IMPROVEMENT OF TULSA ST. & MADISON AVE. 335' E. OF E.L. HYDRAULIC TO S.L. INDUSTRIAL

PROJECT NO. DAKW 706051

CITY OF WICHITA, KANSAS
R.W. LINN, CITY ENGINEER

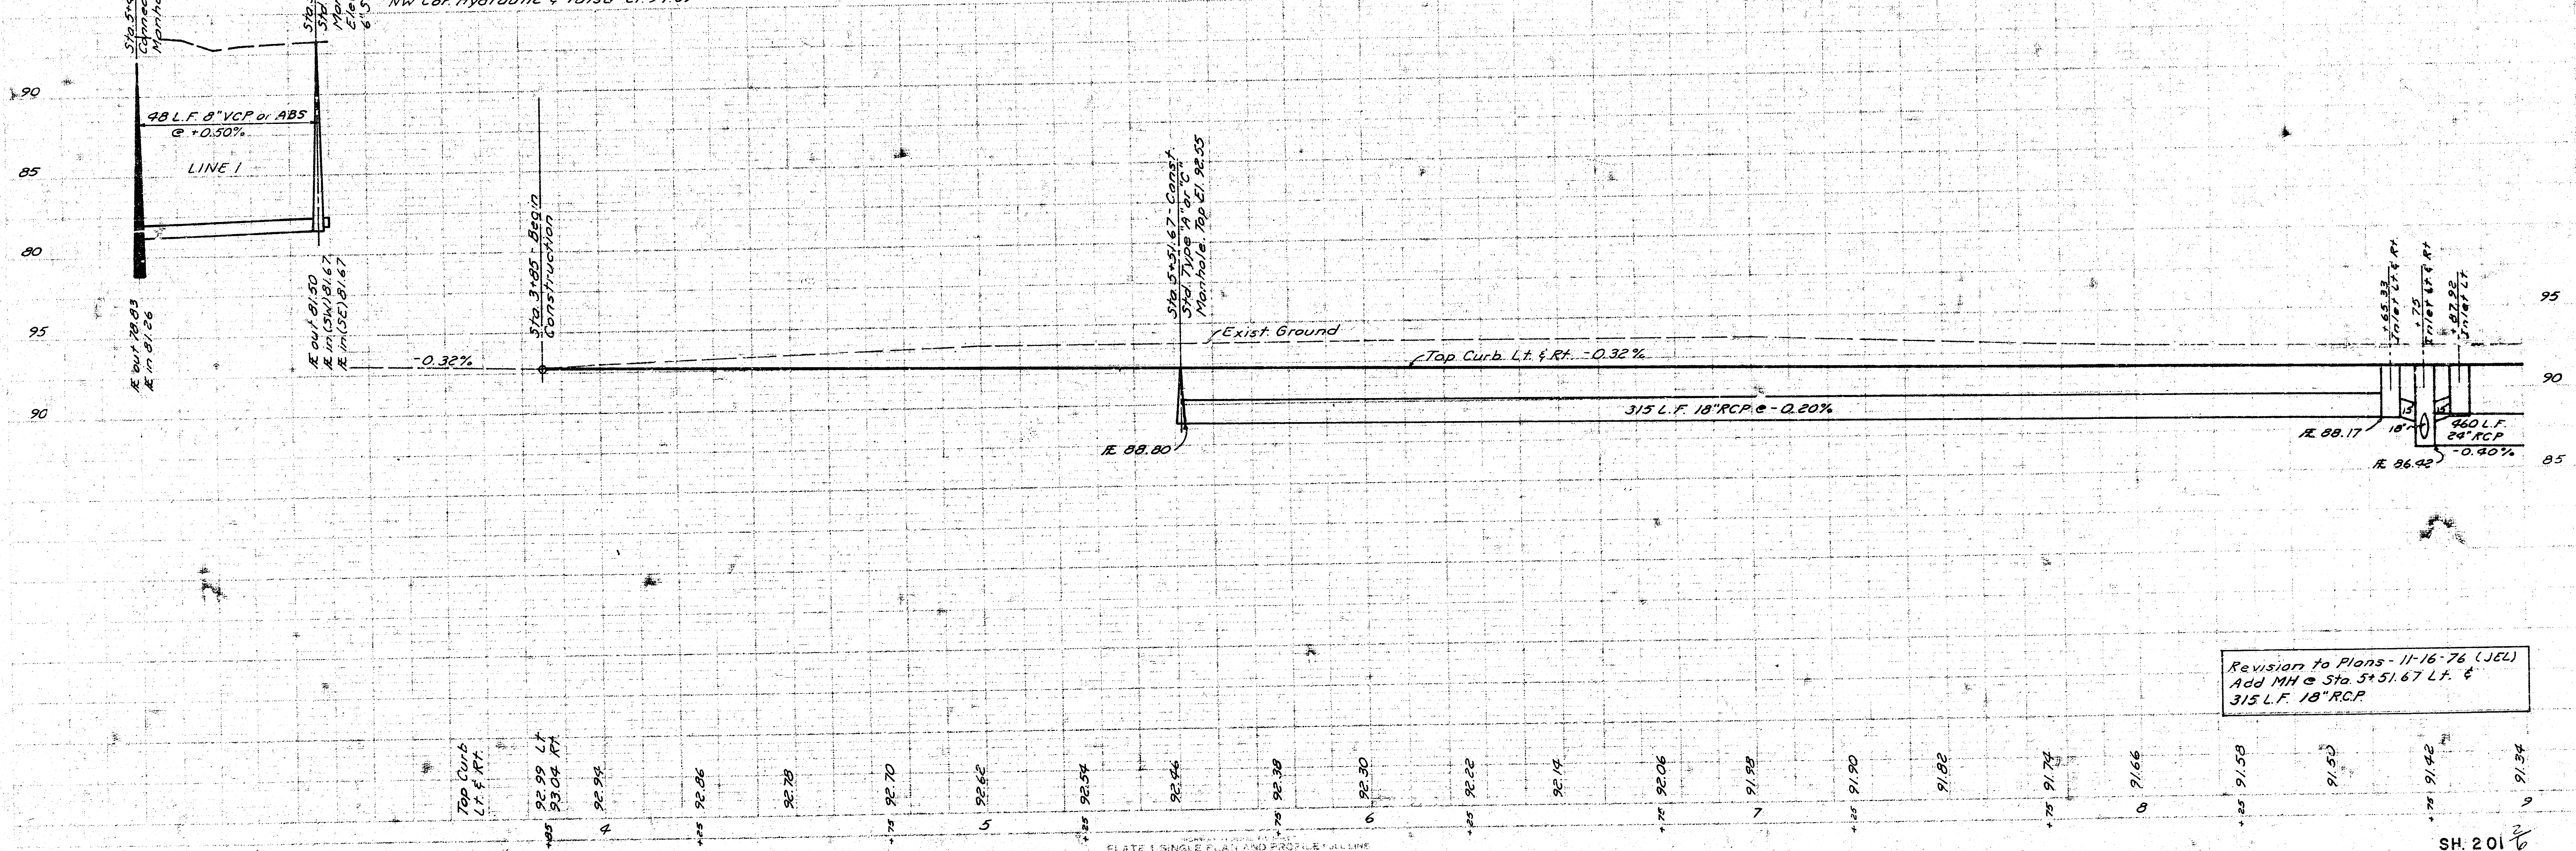
Revision to Plans - 11-16-76 (JEL)
Add MH @ Sta. 5+51.67 L.F. &
315 L.F. 18" RCP
